CAA Environmental Assessment

Title of airspace change proposal	Enabling BVLOS UAS Operations from Keevil Airfield
Change Sponsor	MOD
Project reference	ACP-2021-006
Account Manager	[REDACTED]
Case study commencement date	7 Dec 22 (Formal Submission V1.1)
Case study report as at	1 Feb 23
<p><i>Instructions</i></p> <p>In providing a response for each question, please ensure that the 'status' column is completed using the following options:</p> <ul style="list-style-type: none"> • YES • NO • PARTIALLY • N/A <p>To aid the SARG Lead it may be useful that each question is also highlighted accordingly to illustrate what is:</p> <p>resolved YES not resolved PARTIALLY not compliant NO</p>

Figure 1 Option 2 Design 1

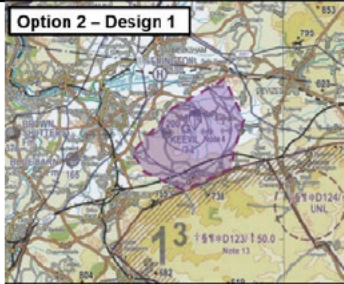
The proposed option (Option 2 Design 1) is shown in figure 1. This option is for multi-point Danger Area, designed to reduce the amount of airspace to the minimum required for The Change Sponsor's RPAS Operations. The Danger Area is 4.9 Nautical Mile (9.1km) wide, orientated in line with Keevil Airfield's runway 06/24, extending from surface to 3,200ft above mean sea level (AMSL).

The danger Areas will be activated by NOTAM; however, it is not stated how often the Danger Area will be activated. Activation will be by NOTAM and only when required, which is nominally likely to be Mon-Fri in daylight hours for periods of 3-6 weeks at a time. There are expected to be one or two BVLOS aircraft sorties a day. This is anticipated to leave a period of time for other airspace users to cross the Danger Area via a Danger Area Crossing Service (DACS). The Danger Area is required to remain active whilst BVLOS aircraft are airborne due to the potential need to recover the aircraft to Keevil Airfield in the event of an emergency.
